Proposal for SAS 2.1 Specification to Enable Support for Active Cables

QUELLAN

August 27, 2008

List of Proposed Modifications to SAS 2.0 to Enable Active Cables

Figure 98 — Mini SAS 4x cable plug connector that attaches to an enclosure universal port

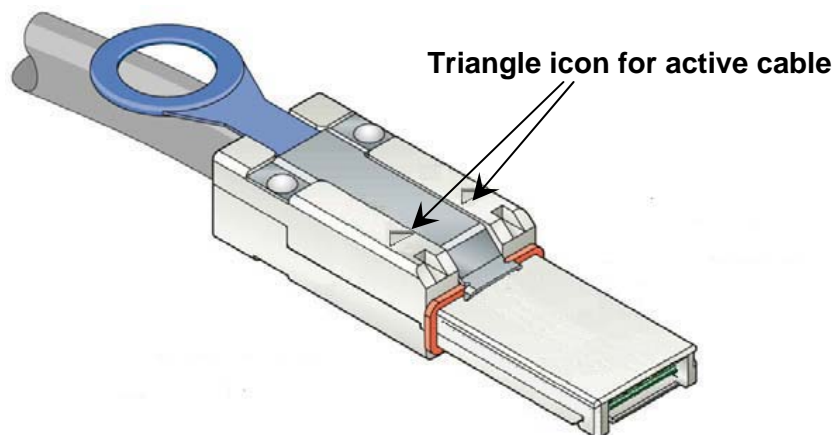
In order to ensure that active cables are not intermateable with passive receptacles, differentiating keying shall be provided by having no key slots on the plug connector and the single key slot on the receptacle connector (per section TBD). In addition, two triangle icons on

each side on the plug connector shall be added to the plug connector to identify an active cable assembly. The plug connector key positions and icons are summarized in Table 58.

Figure 98 shows an active mini SAS 4x cable plug connector that attaches to an enclosure universal port:

Figure M.1 — Dual comparator design for active cable detection

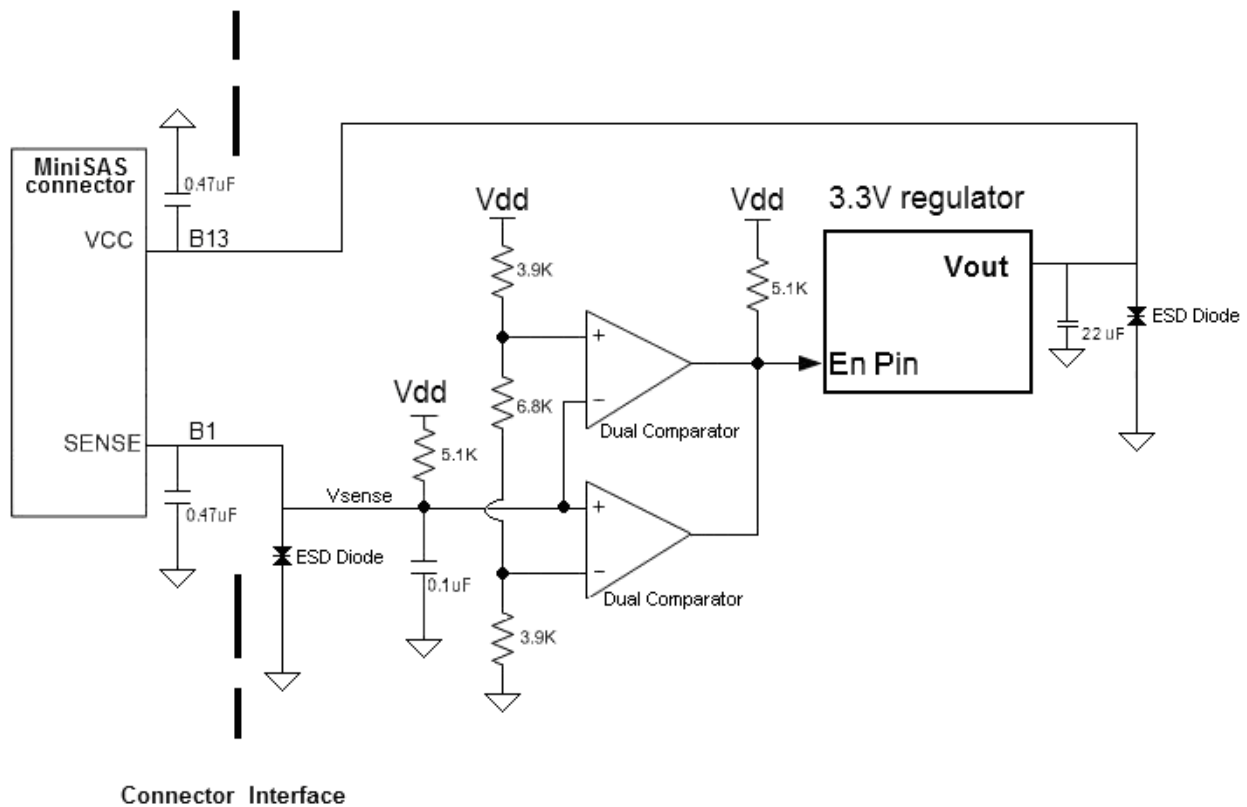
- *Title and other references to the specification is now 2.1 instead of 2.x*
- *The pinout of active mini SAS cables has been changed in Table 60: the Sense pin is now B1 instead of B10, and pin B10 reverts to ground. The change is also reflected in Figure M.1 of Annex M.*

Fig M1 is an example design utilizing a dual comparator to determine from the sense pin on the active cable plug if an active cable is in operation. The circuit then supplies power based upon whether there is an active cable connected to the receptacle.
